Product / Process Change Notification (PCN)	
<input checked="" type="checkbox"/> Major change <input type="checkbox"/> Minor change	
PCN #: PCN_UtRJ45LAN_20230711 Affected Series: WE-RJ45LAN-Series; 749XXX, SXXX PCN Date: April 11, 2023 Effective Date: July 11, 2023	Change Category: <input type="checkbox"/> Equipment / Location <input checked="" type="checkbox"/> General Data <input checked="" type="checkbox"/> Material <input checked="" type="checkbox"/> Process <input checked="" type="checkbox"/> Product Design <input type="checkbox"/> Shipping / Packaging <input type="checkbox"/> Supplier <input type="checkbox"/> Software
Contact: Product Management Phone: +49 (0) 7942 - 945 5001 Fax: +49 (0) 7942 - 945 5179 E-Mail: pcn.eisos@we-online.com	Data Sheet Change: <input checked="" type="checkbox"/> Yes <input type="checkbox"/> No Attachment: <input type="checkbox"/> Yes <input checked="" type="checkbox"/> No

Description and purpose of change: <p>To improve the product reliability, Würth Elektronik will implement a new spot welding design technology. Along with this, further general improvements are done in design and process, like shield plating or wire to shield insulation.</p> <p>

74990100013:

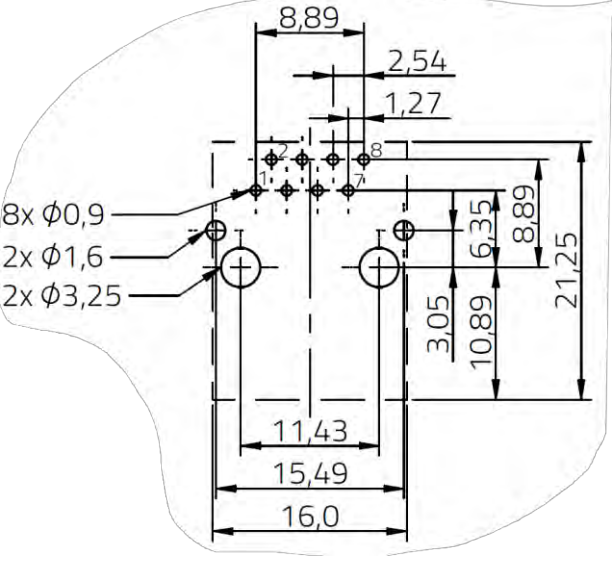
<p>Return Loss: 1-30 MHz 40 MHz 50 MHz 60-100 MHz</p>	<p>Return Loss: 1-30 MHz 30-60 MHz 60-80 MHz 80-100 MHz</p>
<p>Common Mode Rejection: 30 MHz 60 MHz 100 MHz</p>	<p>Common Mode Rejection: 1-30 MHz 30-60 MHz 60-100 MHz</p>
<p>Crosstalk: 80 MHz</p>	<p>Crosstalk: 1-60 MHz 60-100 MHz</p>

<p>74990111211:</p>	
<p style="text-align: center;">BEFORE CORRECTION</p> 	<p style="text-align: center;">AFTER CORRECTION</p>

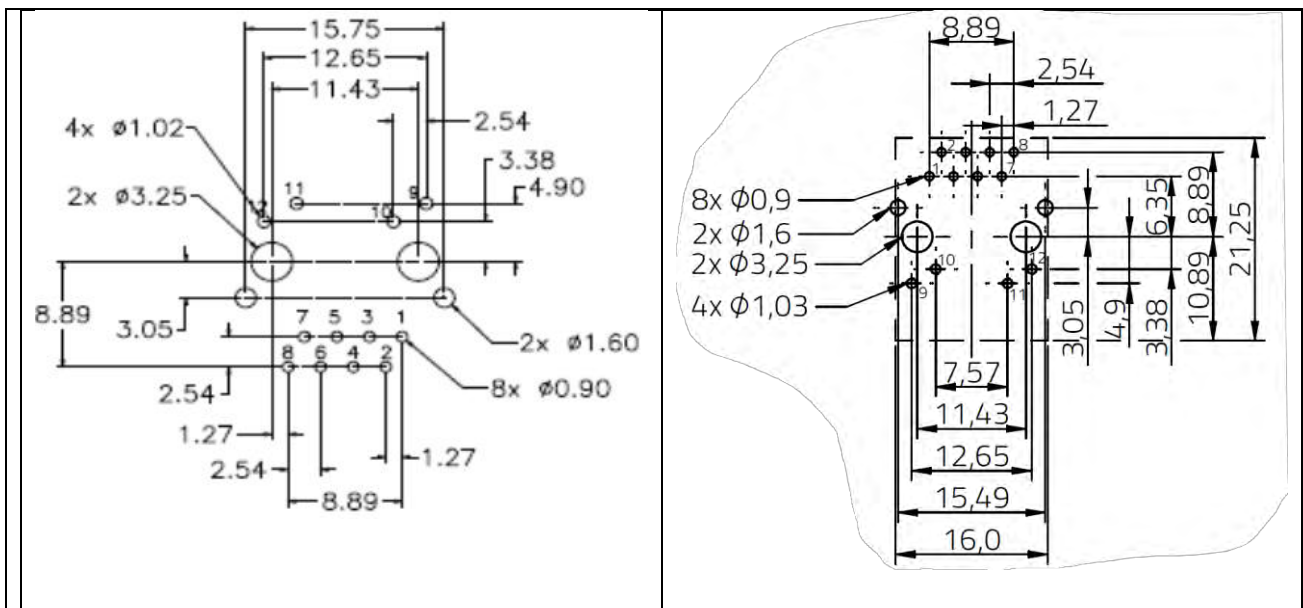
<p>Return Loss: 1-10 MHz 10-30 MHz 30-60 MHz 60-80 MHz</p>	<p>Return Loss: 1-30 MHz 30-60 MHz 60-80 MHz 80-100 MHz</p>
<p>Common Mode Rejection: 1-50 MHz 50-100 MHz</p>	<p>Common Mode Rejection: 1-30 MHz 30-60 MHz 60-100 MHz</p>

<p>Crosstalk: 1-30 MHz 30-60 MHz 60-100 MHz</p>	<p>Crosstalk: 1-60 MHz 60-100 MHz</p>
<p>No panel cutout</p>	
 <p>(Component Side View)</p>

7499111424:

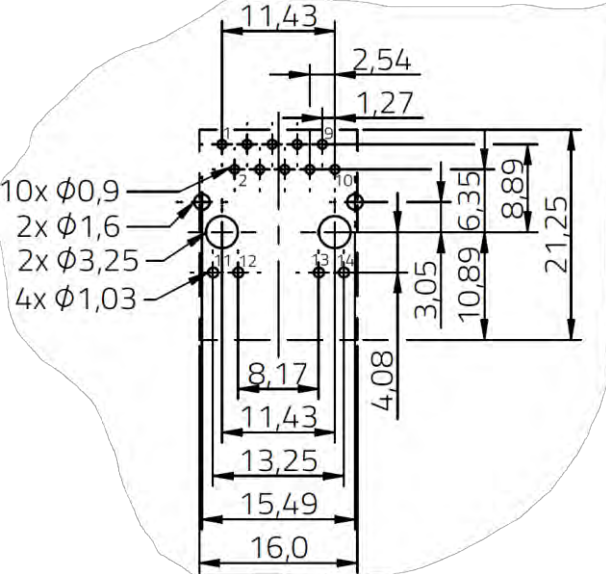
<p>Return Loss: 1-30 MHz 40 MHz 50 MHz 60-100 MHz</p>	<p>Return Loss: 1-30 MHz 30-60 MHz 60-80 MHz 80-100 MHz</p>
<p>Common Mode Rejection: 1-100 MHz</p>	<p>Common Mode Rejection: 1-30 MHz 30-60 MHz 60-100 MHz</p>
<p>Crosstalk: 1-100 MHz</p>	<p>Crosstalk: 1-60 MHz 60-100 MHz</p>

7499011215

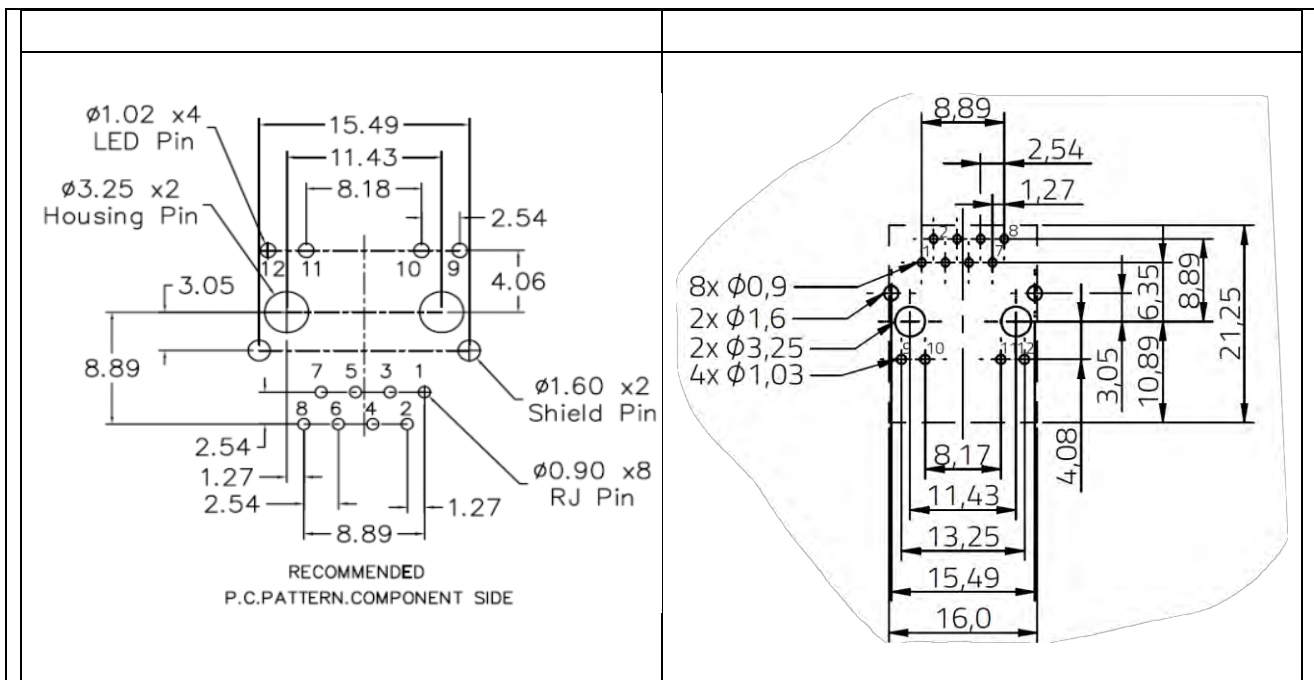
<p>Return Loss: 1-30 MHz 30-45 MHz 45-60 MHz 60-80 MHz</p>	<p>Return Loss: 1-30 MHz 30-60 MHz 60-80 MHz 80-100 MHz</p>
<p>Common Mode Rejection: 1-100 MHz</p>	<p>Common Mode Rejection: 1-30 MHz 30-60 MHz 60-100 MHz</p>
<p>Crosstalk: 1-100 MHz</p>	<p>Crosstalk: 1-60 MHz 60-100 MHz</p>
<p>No panel cutout</p>

7499111440A

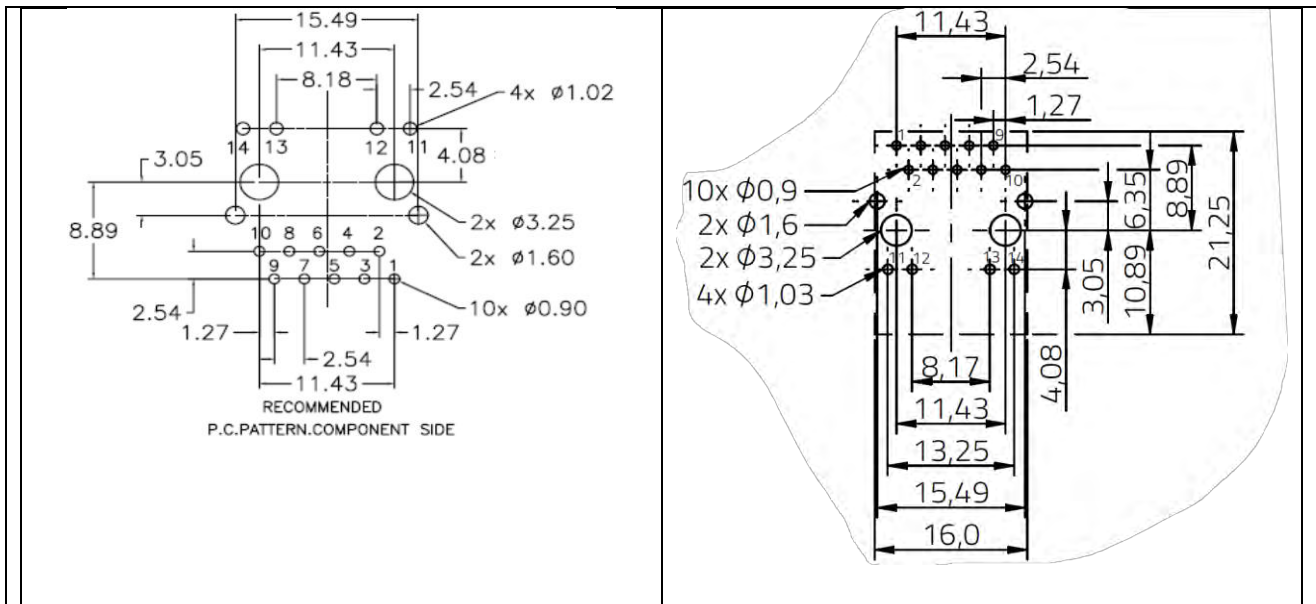
<p>Common Mode Rejection: 1-100 MHz</p>	<p>Common Mode Rejection: 1-30 MHz 30-60 MHz 60-100 MHz</p>
<p>Crosstalk: 1-100 MHz</p>	<p>Crosstalk: 1-60 MHz 60-100 MHz</p>

7499211123:

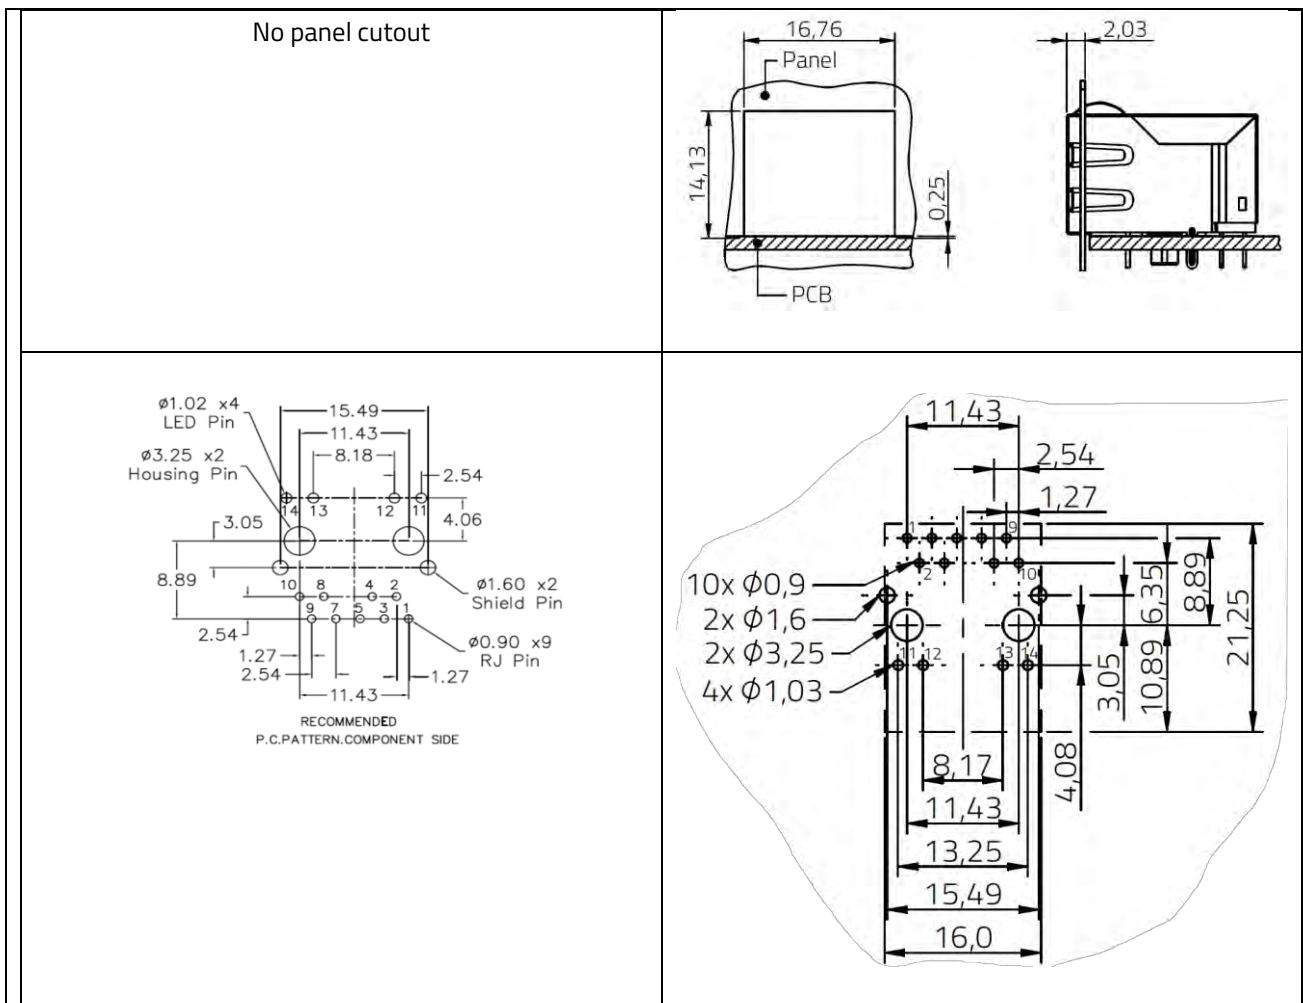
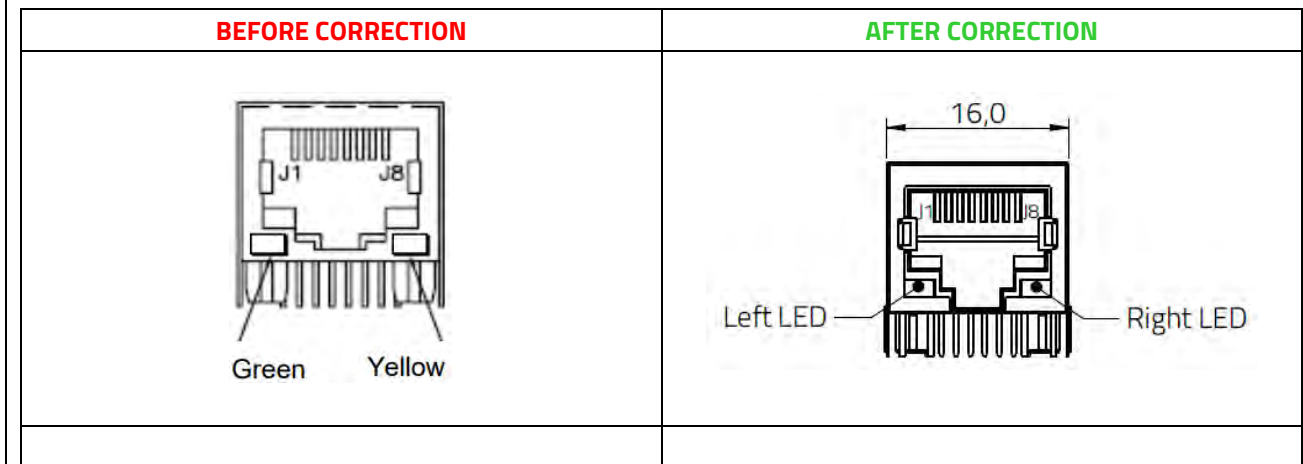
<p>Return Loss: 1-30 MHz 30-45 MHz 45-60 MHz 60-80 MHz</p>	<p>Return Loss: 1-30 MHz 30-60 MHz 60-80 MHz 80-100 MHz</p>
<p>Common Mode Rejection: 1-100 MHz 100-500 MHz</p>	<p>Common Mode Rejection: 1-30 MHz 30-60 MHz 60-100 MHz</p>
<p>Crosstalk: 1-100 MHz</p>	<p>Crosstalk: 1-60 MHz 60-100 MHz</p>

7499211230:

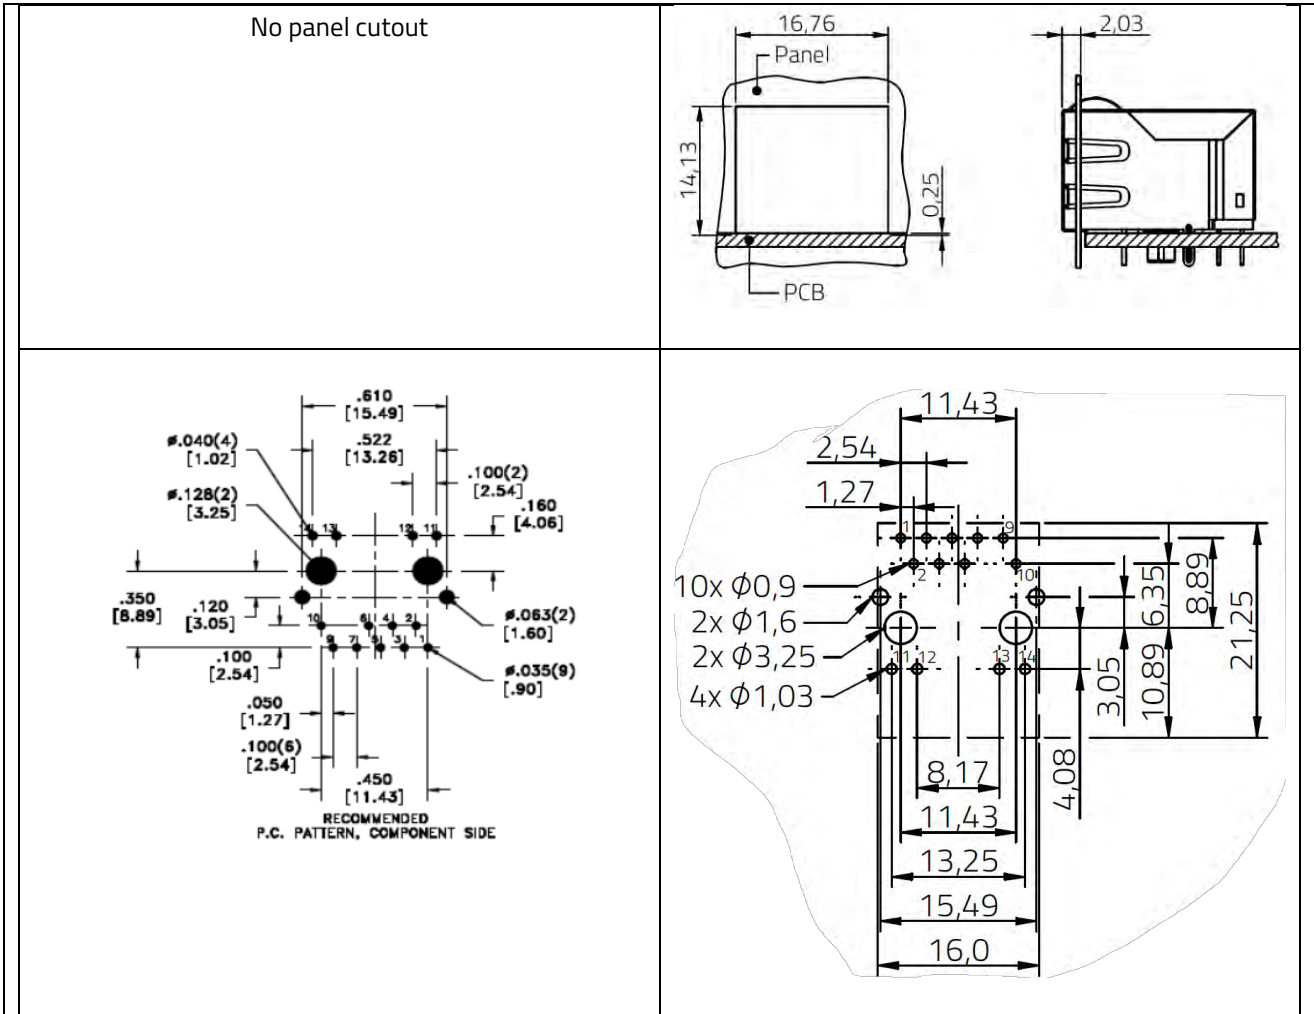
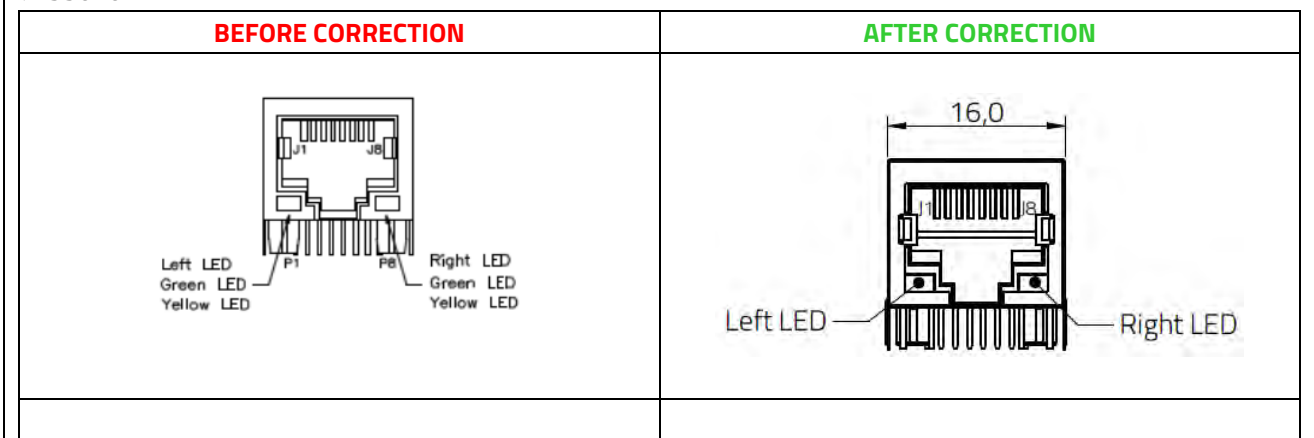
<p>Return Loss: 1-10 MHz 10-30 MHz 30-60 MHz 60-80 MHz</p>	<p>Return Loss: 1-30 MHz 30-60 MHz 60-80 MHz 80-100 MHz</p>
<p>Common Mode Rejection: 1-100 MHz</p>	<p>Common Mode Rejection: 1-30 MHz 30-60 MHz 60-100 MHz</p>
<p>Crosstalk: 1-100 MHz</p>	<p>Crosstalk: 1-60 MHz 60-100 MHz</p>

7499210211:

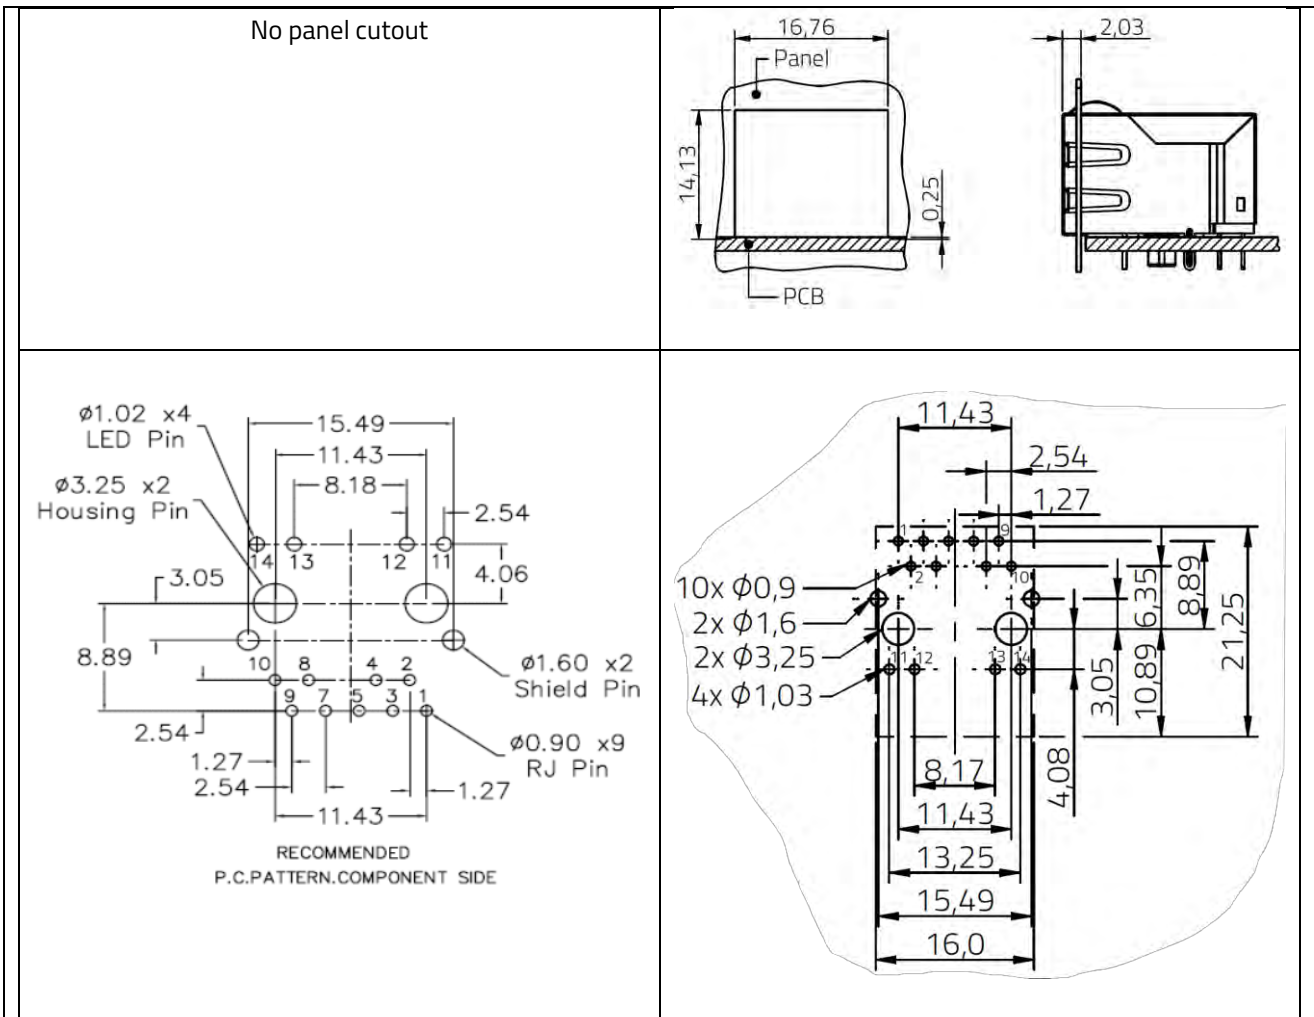
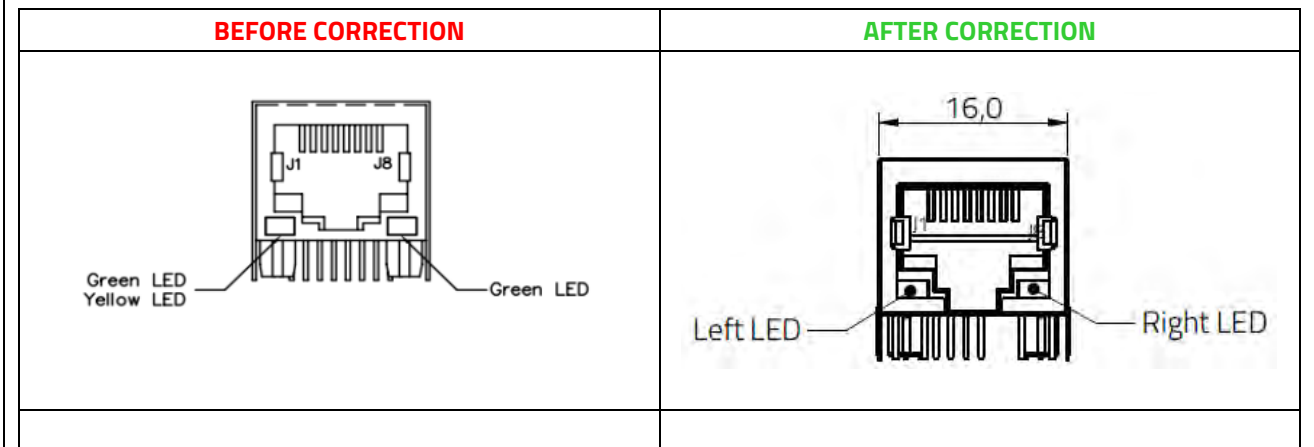
<p>Return Loss: 1-30 MHz 30-45 MHz 45-60 MHz 60-80 MHz</p>	<p>Return Loss: 1-30 MHz 30-60 MHz 60-80 MHz 80-100 MHz</p>
<p>Common Mode Rejection: 1-100 MHz</p>	<p>Common Mode Rejection: 1-30 MHz 30-60 MHz 60-100 MHz</p>
<p>Crosstalk: 1-100 MHz</p>	<p>Crosstalk: 1-60 MHz 60-100 MHz</p>
